**SUBJECT: BRAIDWOOD STATION, UNITS 1 AND 2—NRC INTEGRATED INSPECTION
REPORT 05000456/2017004; 05000457/2017004; AND EMERGENCY
PREPAREDNESS ANNUAL INSPECTION REPORT 05000456/2017501;
05000457/2017501**

Report No: 05000456/2017004; 05000457/2017004;
05000456/2017501; 05000457/2017501

Facility: Braidwood Station, Units 1 and 2

Description of Circulating Water Blowdown Piping at Braidwood

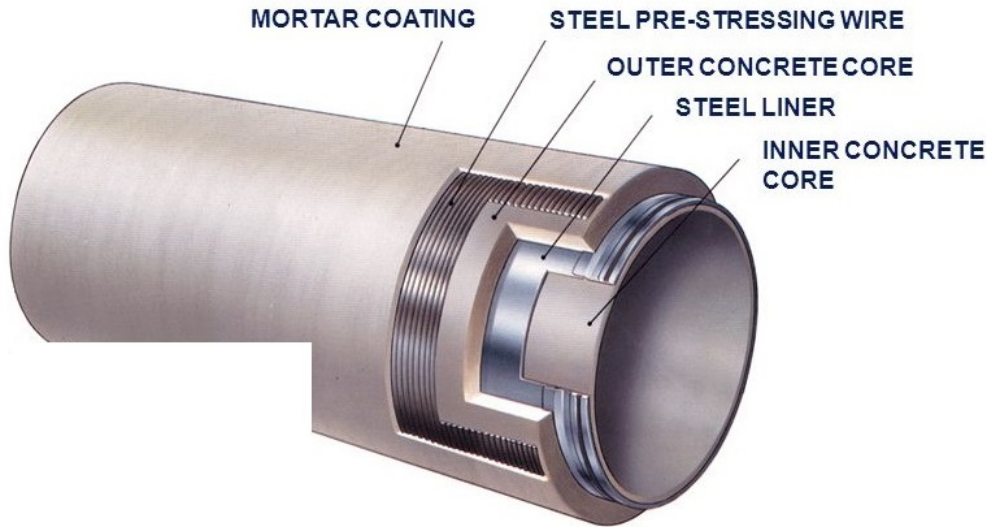
The inspectors identified weaknesses in the licensee's evaluations associated with maintaining the integrity of the CWBD piping. The NRC inspections performed during this inspection period prompted the licensee to accelerate their follow-up inspection plans. These follow-up inspections resulted in the discovery of cracks in the mortar and concrete surrounding the steel piping that were subsequently repaired. These cracks were repaired prior to any CWBD piping leakage. One finding of minor significance was identified.

Although a follow-up RFTC inspection of the CWBD piping was planned for 2018, the licensee had not identified other methods to reduce the risk of failure for the distressed pipe segments and industry guidance to reduce the risk of failure was available. For example, an EPA-sponsored study described ways to reduce the risk of failure for

In response to the inspectors' observations, the licensee elected to accelerate the schedule for the planned 2018 inspection of the CWBD piping. By December 16, 2017, the licensee, utilizing specialized services of a vendor, completed a follow-up RFCT inspection and visual examination of the interior surface of the CWBD piping. During this examination, the licensee identified one pipe segment with two internal axial cracks of the inner concrete core. The licensee excavated this pipe segment to facilitate repairs and take samples of groundwater and the soil adjacent to this pipe segment.
